**MORE PEOPLE BIKING
MORE OFTEN**

Bike Winnipeg Comments on Wolseley to Downtown Recommended Design

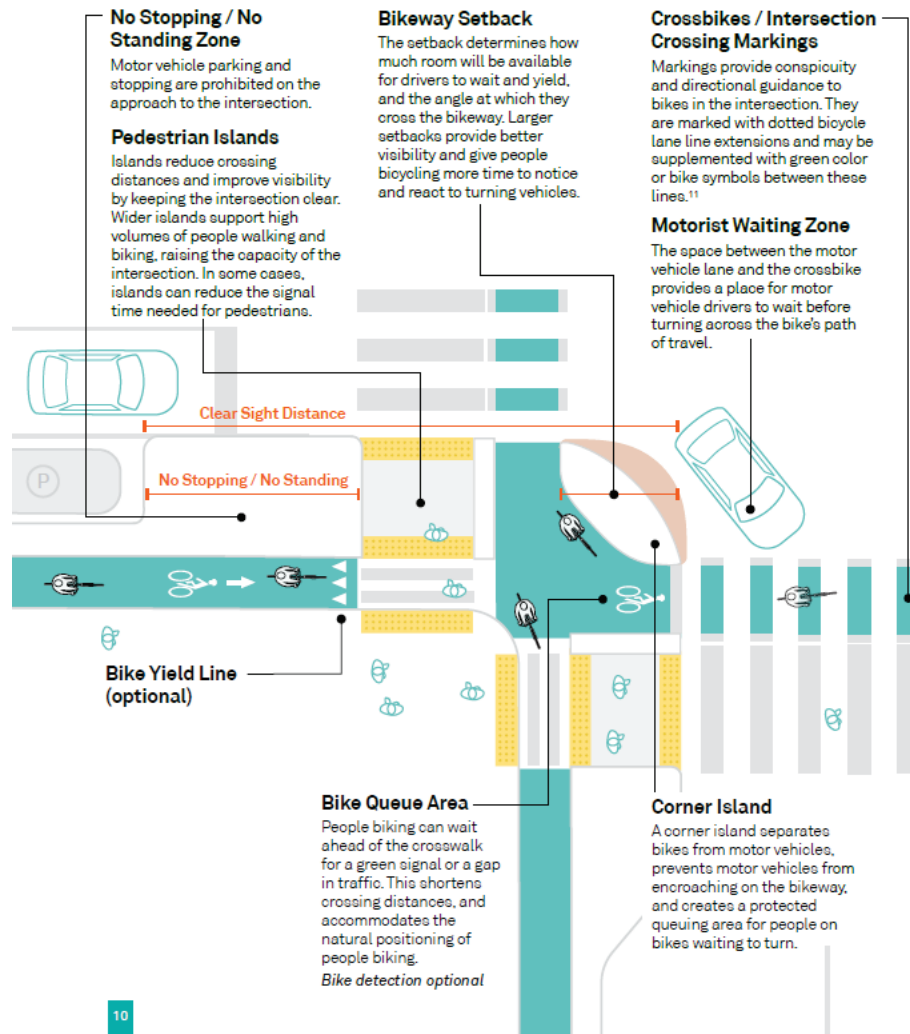
- At Young at Balmoral, provide a place for cyclists to stop and wait for a safe gap in traffic before crossing Balmoral and continuing north into the Broadway Neighbourhood Centre and Park.

A safe crossing of Balmoral @ Young needs to be included to provide safe access to the Broadway Neighbourhood Centre, park and beyond.

Wolseley - Sherbrook to Maryland (Asymmetrical)

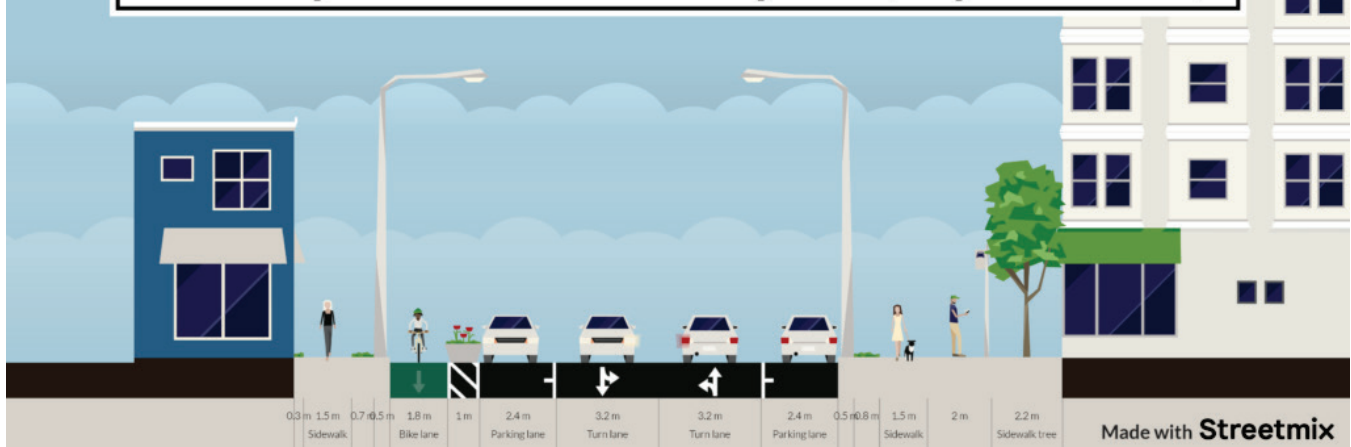
6. Design the intersection at Maryland and Westminster to provide a safe transition for someone biking south along Maryland and turning east onto Westminster.
7. For cyclists traveling north over the Maryland Bridges and turning west, add a protected lane westbound on Wolseley between Sherbrook and Maryland.
 - For someone riding between Wellington Cr @ Academy and Wolseley @ Greenwood, the detour being recommended from Wolseley to Westminster is a 23% increase in distance, plus additional traffic signals and stop signs. That's a detour most people will not be willing to make.

A protected westbound bike lane on Wolseley would overcome the need for a substantial detour for those heading west off of Sherbrook. East bound cyclists would need to take the lane, but traffic would be much reduced, and signage could be installed to encourage people on bike to 'take the full lane'. Buses would stop in traffic lanes, but this would allow for a proper bus shelter on the north side of Wolseley where none now currently exists.

Wolseley - Maryland to Chestnut

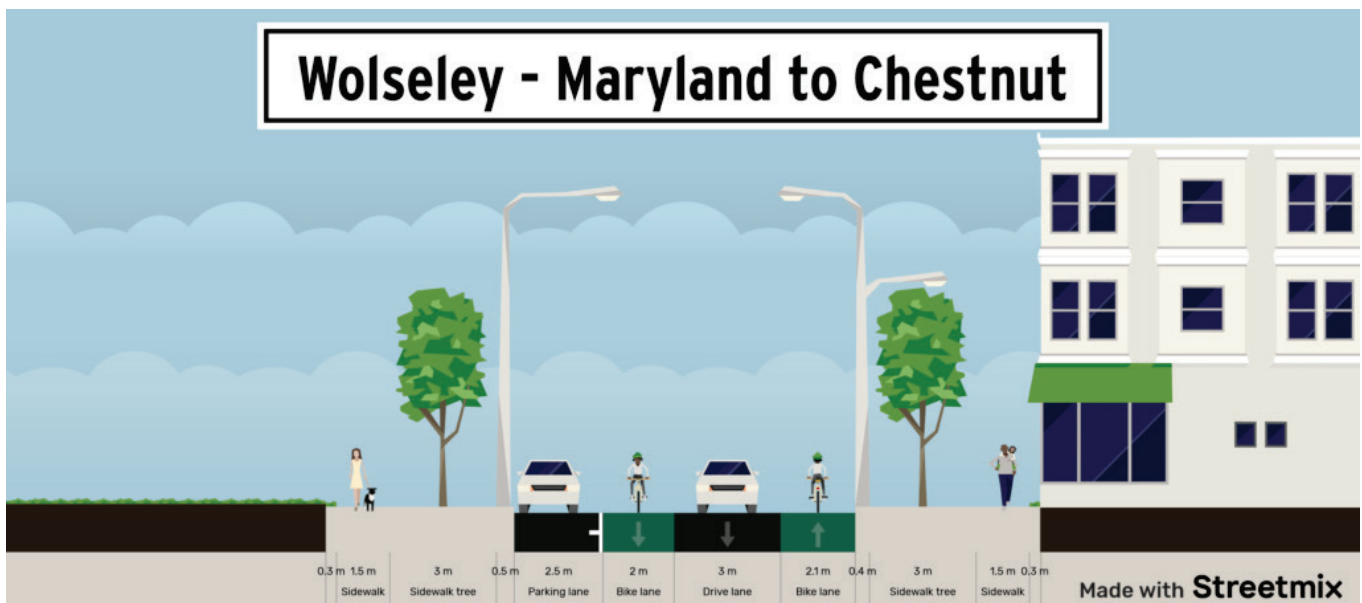
- On Wolseley between Maryland and Chestnut, if there is no room for a protected bike lane running west, add a wide painted buffered bike lane to provide better definition for people on bikes. That would retain the parking, retain the eastbound counter-flow bike lane, retain the westbound traffic lane but would add a bike lane for people biking west instead of forcing them into a mixed traffic lane that is wider than recommended for a mixed traffic lane.

If space cannot be found for a fully protected bike lane through one way sections of Wolseley and Westminster west of Maryland, there should at least be room for painted bike lanes.
